Chesapeake modifications to Regional Standards Third Edition

WS_02.tif

VALVE SETTING DETAIL

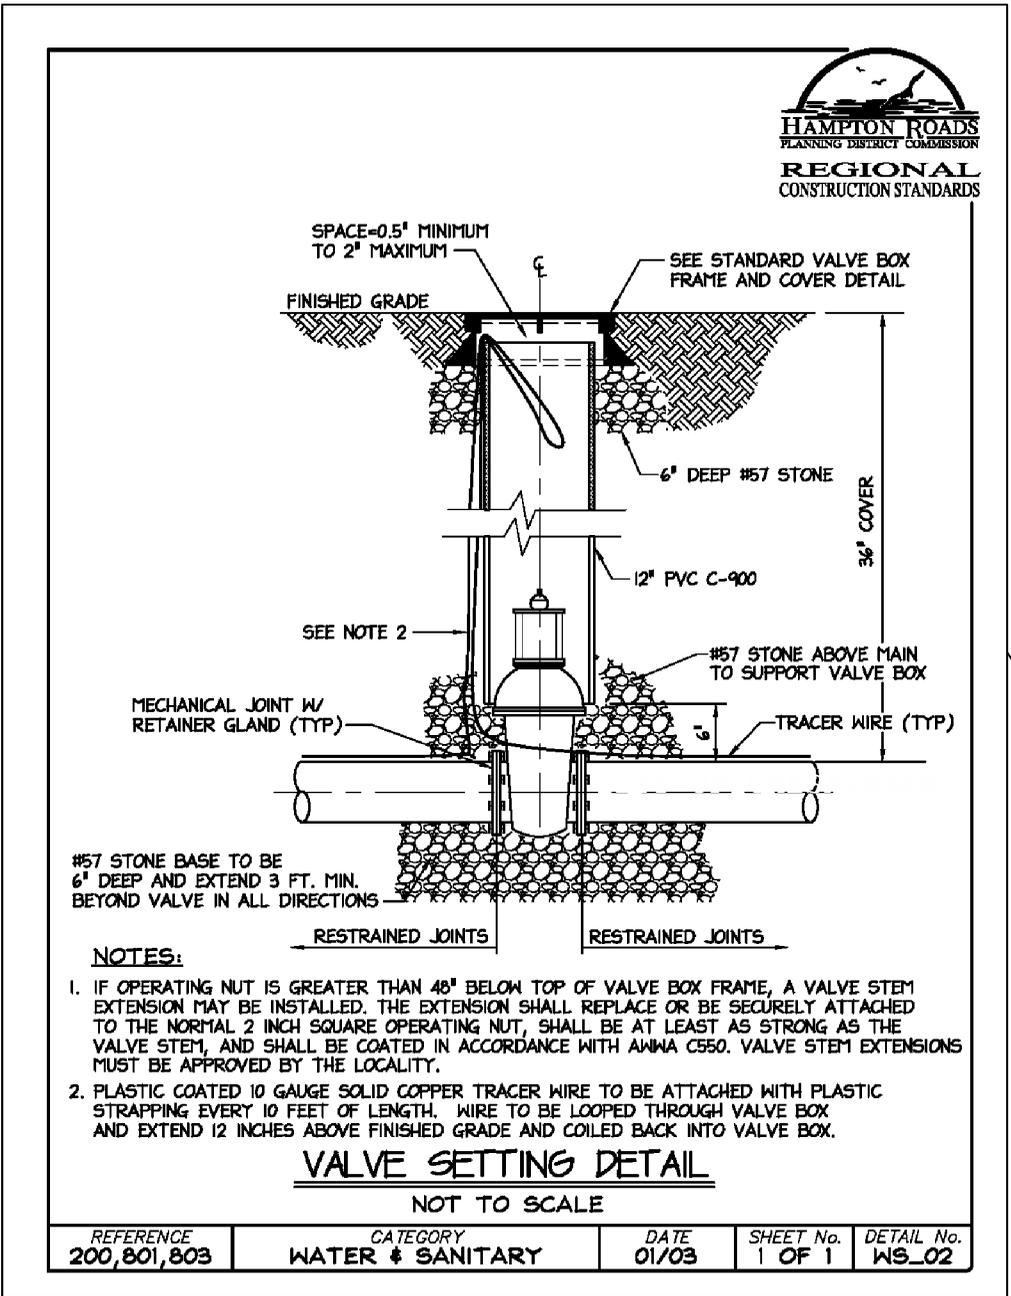
1. Delete note 1.
2. Two bricks are to be placed under the riser for the valve to provide support.
3. Remove stone bedding from around valve and replace with sand.
4. Replace the #57 stone under the valve box frame with #26A stone.
5. The riser pipe shall be centered over the valve nut and installed perpendicular to the pipeline.
6. All valves are to be set so that the valve stem is plumb.
